AENC-NG-CNS-REP-0343

Norwich to Tilbury

Document: 8.11 Approach to Scenarios - Tracked Changes Version

Final Issue E

Table 2.1 Norwich Main Substation (Section A)

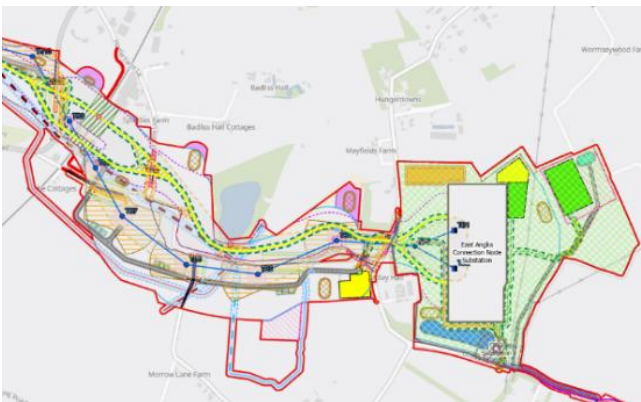
Type	Description (Text & Images from ES Chapter 4)	Relevant Stakeholders	Current Status	Securing Mechanism	Decision
OHL	 Figure 4.1: Proposed Project Design (document reference 6.4.F1) and Figure 4.2: Proposed Project Design – Permanent Features (document reference 6.4.F2) show an overhead line alignment exiting the Norwich Main Substation between RG001 and RG007. The Limits of Deviation (LoD) and Order Limits in this location have been widened to the east to allow flexibility to change the alignment should the Innova Renewables battery storage facility to the south of the substation not proceed.	Innova Renewables Limited SSDE ProjCo Limited	Hall Farm BESS secured planning permission in July 2025. The In the current SoGG [APP-112], the Applicant had previously expressed a preference for the eastern alignment if the Hall Farm BESS doesn't proceed. However, following ongoing discussions with Innova Renewables Limited, the Applicant has confirmed that it will proceed with the western corridor alignment. Detailed design engagement with Innova	Assuming agreement reached, we anticipate. The Applicant anticipates the securing mechanism will be through: Outline Code of Construction Practice Commitments Register Updated Works and Land Plans Statement of Common Ground with Innova Renewables (for latest position see Document Reference 5.9.25 [Revision B])	Decision to proceed with western corridor only. The Applicant has submitted 2.3 Works Plans – Section A [Revision B]; 2.16 Trees and Hedgerows to be Removed and/or Managed Plans – Section A [Revision C] and 8.15.4 Class of Rights Plans - Section A – Scenario 1 (Table 2.1) [Revision A] as a result of the LoD reduction. Land Plans will be submitted at Deadline 8. Decision pending further resolution of

Type	Description (Text & Images from ES Chapter 4)	Relevant Stakeholders	Current Status	Securing Mechanism	Decision
			Renewables is ongoing to agree project interactions and define a project corridor and remove uncertainty for relevant stakeholders. SSDE ProjCo Limited have also expressed a preference for the Applicant to utilise the western corridor which would result in less interactions between the two projects. All parties are continuing to engage on this matter and the Applicant seeks to have an agreed outcome by Deadline 7.	Statement of Common Ground <u>Statement of Common Ground with Equinor (for latest position see Document Reference 8.3.10 [Revision C])</u>	detailed design interactions between the different projects. Further positive detailed design engagement has since taken place between the projects, and parties are cooperating to formalise a proposed solution. The Applicant seeks to have an agreed outcome by Deadline 7.

Table 2.2 Anglian Water Sewage Works south of Tabernacle Lane (Section A)

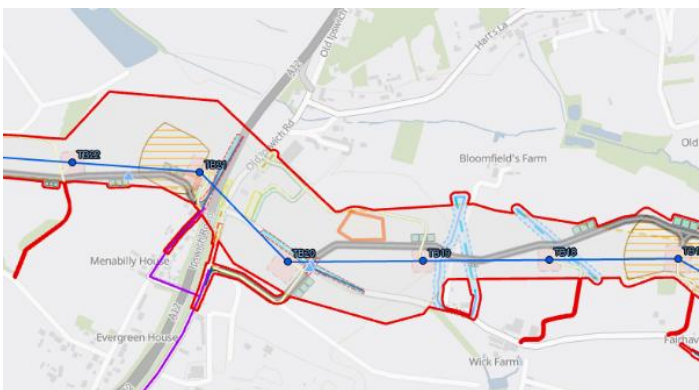
Type	Description (Text & Images from ES Chapter 4)	Relevant Stakeholders	Current Status	Securing Mechanism	Decision
Access	 Figure 4.1: Proposed Project Design (document reference 6.4.F1) shows two haul roads within the Order Limits between RG40 and RG42. Two<u>The two</u> haul roads are presented to provide an alternative haul road that avoids crossing through an<u>the existing</u> Anglian Water sewage works<u>Recycling Centre</u> and potential land it has noted may be used for reed planting<u>plans to develop under Asset Management Plan 8 (AMP8)</u>. The haul road scenario is subject to a wider Anglian Water/ National Grid Electricity Transmission (NGET) discussion on the utilisation of a parcel of land south of the Forncett End water treatment plant<u>Water Recycling Centre</u> between RG41 and RG42. While the parcel of the land the proposed <u>overhead line (OHL)</u> alignment occupies is not currently utilised by Anglian Water; <u>(except for an outflow pipe)</u>, <u>they have a plan to develop it</u> is in their future business plans and<u>current AMP8</u>	Anglian Water Services Limited (AW)	No agreement with AW regarding impact on<u>Interface between the Project and the Anglian Water</u> Forncett End Water Recycling Centre (WRC) and potential future land use, <u>with its AMP8 development, are not yet finalised.</u> AW<u>Anglian Water</u> and the Applicant are progressing a number of potential solutions working to define an agreed outcome. <u>The Applicant awaits further detail about the AMP8 development which will inform the preferred route for the Haul Road.</u> Further detail is provided at ID 7.11<u>7.10</u> of the Applicant's draft <u>SoCG Statement of</u>	Assuming agreement reached, we anticipate securing mechanism will be through The Statement of Common Ground with AW Anglian Water (see Document Reference 5.9.26 [Revision C]) sets out the background to Anglian Water's requirements and next steps. <u>Code of Construction Practice</u>	No change currently as the Scenario is dependent on external factors and on-going third party<u>third-party</u> engagement and agreement. The Applicant seeks to make a decision by Deadline 7.<u>The Applicant and Anglian Water are collaborating to co-ordinate their projects. The Applicant expects this to be completed post examination which will enable a decision on both the haul road and compensatory land.</u>

Type	Description (Text & Images from ES Chapter 4)	Relevant Stakeholders	Current Status	Securing Mechanism	Decision
	capital plan so a mutually agreeable solution is sought. The Applicant has included within the DCO, proposed a a compensatory parcel of land swap for Anglian Water to utilise instead utilise a parcel of land adjacent to the existing site. Conversations with Anglian Water are ongoing to agree a solution.		Common Ground with Anglian Water [REP4-101]. (see Document Reference 5.9.26 [Revision C]). The Applicant seeks to have an agreed outcome by Deadline 7.

Table 2.3 Silica sands mineral site west of the proposed new EACN Substation (Section C)

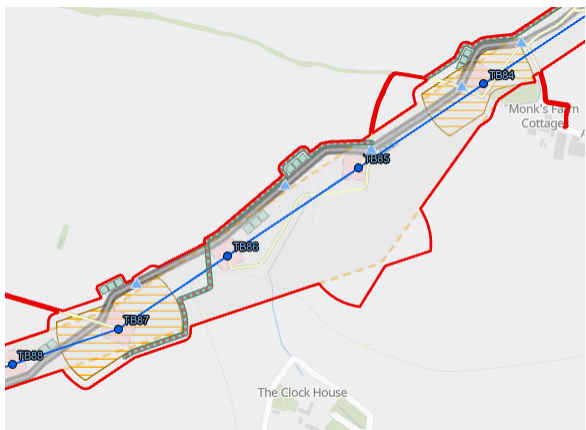
Type	Description (Text & Images from ES Chapter 4)	Relevant Stakeholders	Current Status	Securing Mechanism	Decision
OHL, UGC & Minerals	 Figure 4.1: Proposed Project Design (document reference 6.4.F1) and Figure 4.2: Proposed Project Design – Permanent Features (document reference 6.4.F2) shows an overhead line alignment and underground cable alignment between TB1 and TB8. The LoD and Order Limits have been widened in this area to allow flexibility to facilitate a swap of the overhead line and underground cable north or south of Little Bromley Road, subject to the progression of the silica sands minerals site, i.e. locating the underground cables to the north of Little Bromley Road would reduce sterilisation of potential silica sands mineral site. Scenario A: Overhead line pylons TB5, TB6 and TB7 located to the south of the road with the underground cable located to the north of the road.	Suffolk County Council (SCC)	Feedback from SCC's Mineral Planning team indicates there may be no decision on the site's inclusion until after the examination closes. The Applicant has also received further details of the potential impact of construction on the fruit farm. The Applicant is exploring adjustments to working practices, cable swathe requirements and potential mitigations (including the provision of other land). The Applicant is progressing with Scenario A, with overhead line pylons TB5, TB6 and TB7 located to the south of Little Bromley Road and the	Assuming agreement reached, we anticipate securing mechanism will be through: • Works and Land Plans • Statement of Common Ground (for latest position see Document Reference 8.3.28 [Revision D])	Decision to proceed with Scenario A, as originally proposed, subject to minor micro-siting at detailed design.

Type	Description (Text & Images from ES Chapter 4)	Relevant Stakeholders	Current Status	Securing Mechanism	Decision
	Scenario B: The cable alignment and Overhead Lines are changed with cables swapped to the south of the road and TB5 to TB7 to the north.		underground cable located to the north of the road. However, the Applicant is continuing to explore whether there is a requirement for a modified version of the current Scenario A. This is subject to detailed design work. Design options under development.

Table 2.8 Crest Nicholson housing development south of the A127 (Section G)

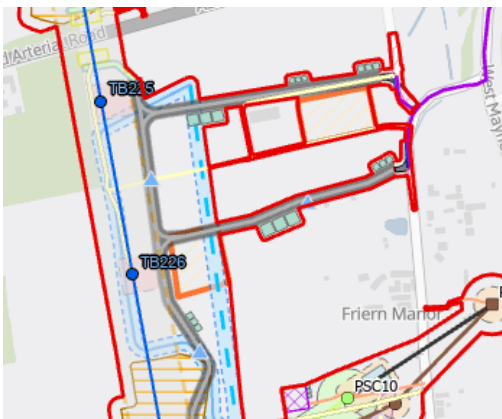
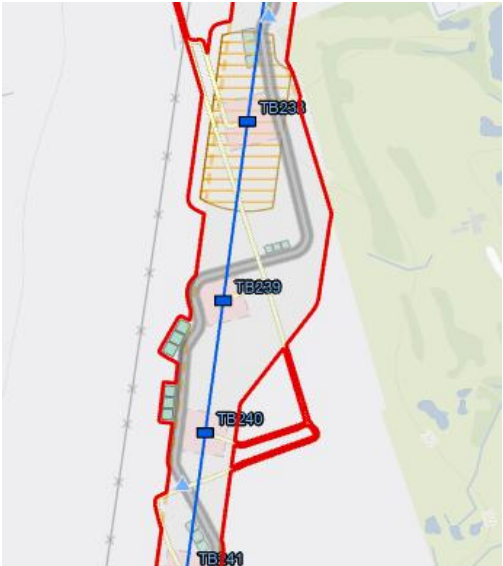
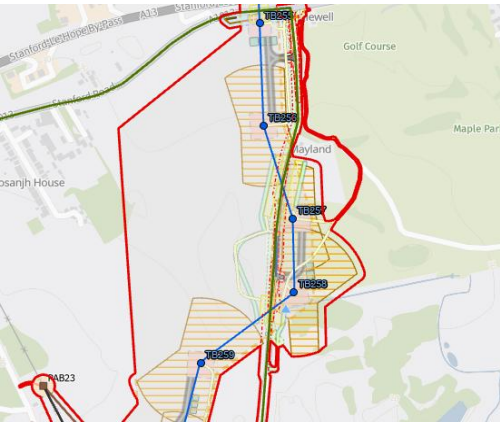
Type	Description (Text & Images from ES Chapter 4)	Relevant Stakeholders	Current Status	Securing Mechanism	Decision
Access	 Figure 4.1: Proposed Project Design (document reference 6.4.F1) shows two haul roads/construction access arrangements within the Order Limits between TB225 and TB226. Two haul roads are presented to provide an alternative haul road should the Crest Nicholson housing development progress.	Crest Nicholson	Northern scenario to be withdrawn upon submission of a planning application for the Crest Nicholson scheme. <u>The Applicant has added an additional commitment within Table 6.1 of the 7.2 Outline Code of Construction Practice [Revision G] requiring consideration of this matter at a later stage.</u> There is already<u>The Applicant also has</u> an agreement in place with the housebuilder.	Assuming agreement reached, we anticipate securing mechanism will be through: - Statement of Common Ground <u>(for the latest position see Document Reference 8.3.14 [Revision C])</u> - Code of Construction Practice	Decision to be made once the third party planning application has been submitted. Outcome awaited.

Table 2.12 River Stour crossing west of Stratford St Mary (Section C)

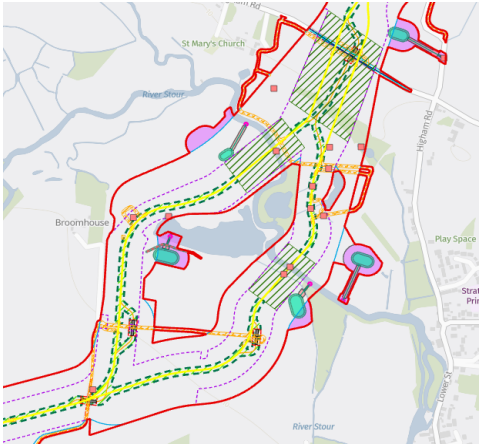
Type	Description (Text & Images from ES Chapter 4)	Relevant Stakeholders	Current Status	Securing Mechanism	Decision
UGC	 Figure 4.1: Proposed Project Design (document reference 6.4.F1) and Figure 4.2: Proposed Project Design – Permanent Features (document reference 6.4.F2) shows two underground cable crossings of the River Stour. The LoD and Order Limits have been widened at the crossing of the River Stour to allow for a double eastern and western crossing or a single crossing (either an eastern only or western only crossing), subject to detailed design of the trenchless crossing methods and detailed ground investigation. The area is constrained by various water bodies, a high-pressure gas main and Source Protection Zone 1. The double eastern and western crossing would not interact with the Source Protections Zone 1. However, if a single western crossing was taken forwards following detailed design the Project would interact with a Source Protection Zone 1.	N/A	Base assumption that there may be a need for two corridors – design will be dictated by grounds conditions. Would be premature to reduce flexibility at this stage, even though the Applicant's aspiration is to proceed with one corridor only. Any interactions with the gas main would be regulated through existing Protective Provisions included in the draft DCO.	Not relevant given reason for wider limits.	Retaining flexibility into delivery is required to respond both to detailed ground condition investigations and the outcome of each trenchless crossing installation drive.

Table 2.16 Thurrock Airfield and Low Heights west of Langdon Hills Golf and Country Club (Section H)

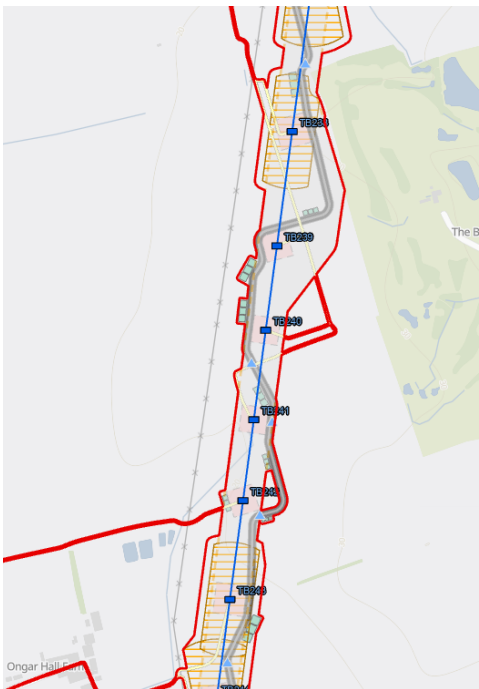
Type	Description (Text & Images from ES Chapter 4)	Relevant Stakeholders	Current Status	Securing Mechanism	Decision
OHL	 Figure 4.1: Proposed Project Design (document reference 6.4.F1) and Figure 4.2: Proposed Project Design – Permanent Features (document reference 6.4.F2) show an alignment between TB238 and TB243. Low height pylons are proposed between TB238 and TB243 to cater for Thurrock Airfield. However, should a housing development be brought forwards at Thurrock Airfield and/or the airfield be closed, low height pylons would not be required and standard lattice pylons would be installed instead.	Thurrock Airfield Operator and Users	Pylon height remains dependent on the status of Thurrock Airfield. As of April 2026, the appeal against refusal of housing proposals for the site was dismissed and the Applicant assumes the airfield will continue to operate and therefore low height pylons retained as the design.	Assuming dismissal of appeal and agreement being reached with the airfield, we anticipate securing mechanism will be through: • SOCG with airfield operator (for the latest position see Document Reference 5.9.23 [Revision D]) • Permitted under Article 5 (1)(b)(i) • Work Plans (Table of Parameters) • Code of Construction Practice	No change to preferred design following the dismissal of the appeal and the Applicant is proceeding on the basis of the continued operation of the airfield, which requires the design to include low height pylons between TB238 and TB243. The Applicant has included a commitment within 7.2 Outline Code of Construction Practice [Revision F] [REP6-072] following engagement with Thurrock Airfield Operator at Deadline 6.

Table 2.17 Temporary construction compounds (Section G/H)

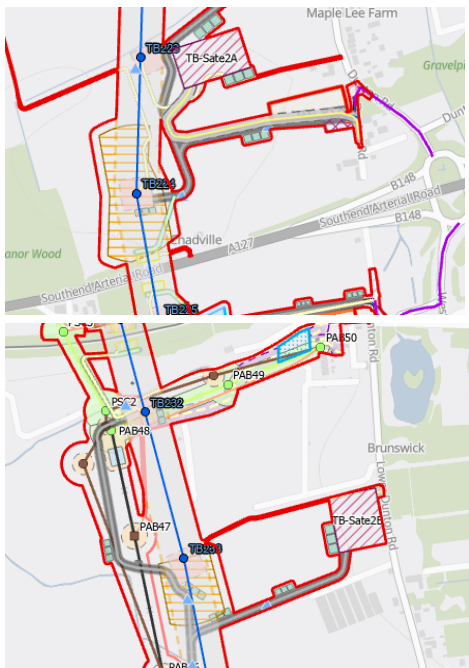
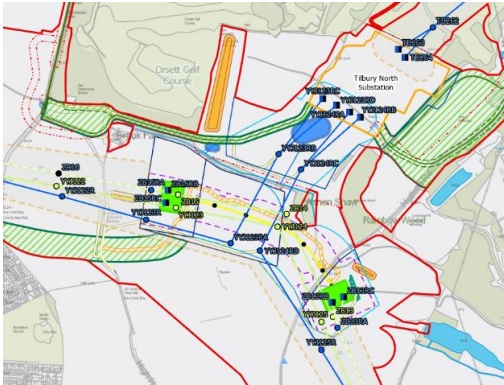
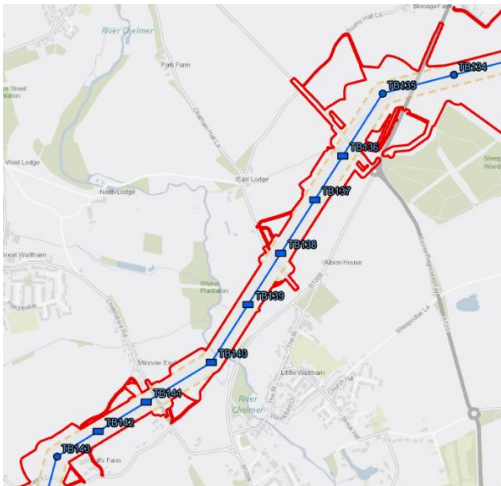
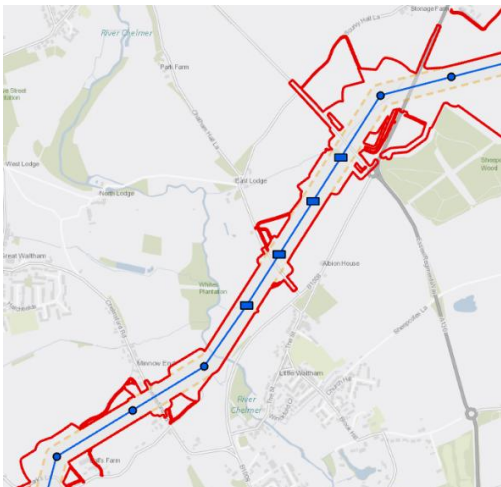
Type	Description (Text & Images from ES Chapter 4)	Relevant Stakeholders	Current Status	Securing Mechanism	Decision
Compound	 There are two options for a satellite compound in Basildon, due to a planning application for Brentwood Housing Development (21/01525/OUT) which has yet to be determined. Only one satellite compound would be taken forward depending upon the outcome of the planning application. The two options are: - Option 1) a compound off Brentwood Road, near TB223 (TB-Sate2A) - Option 2) a compound at Lower Dunton Road, near TB233, Basildon (TB-Sate2B).	Affected landowners	The planning application (21/01525/OUT) was approved (subject to s106) on 16 June 2026. The Applicant is taking forwards Option 1 - a satellite compound near TB223. The Applicant is engaging with the landowner to explore opportunities within the available flexibility to reduce effects.	Assuming agreement reached, we anticipate securing mechanism will be through: Land Plans – change land plots not required to Class 8 - Code of Construction Practice	Decision to proceed with Option 1. Application documents relevant to Option 1 will be submitted no later than Deadline 8. 8.15.7 Class of Rights Plans – Section H – Scenario 17 (Table 2.17) [Revision A], 2.16 Trees and Hedgerows to be Removed and/or Managed Plans - Section H [Revision D] and 7.2 Outline Code of Construction Practice [Revision G] have been submitted at Deadline 7. Updated Land Plans will be submitted at Deadline 8.
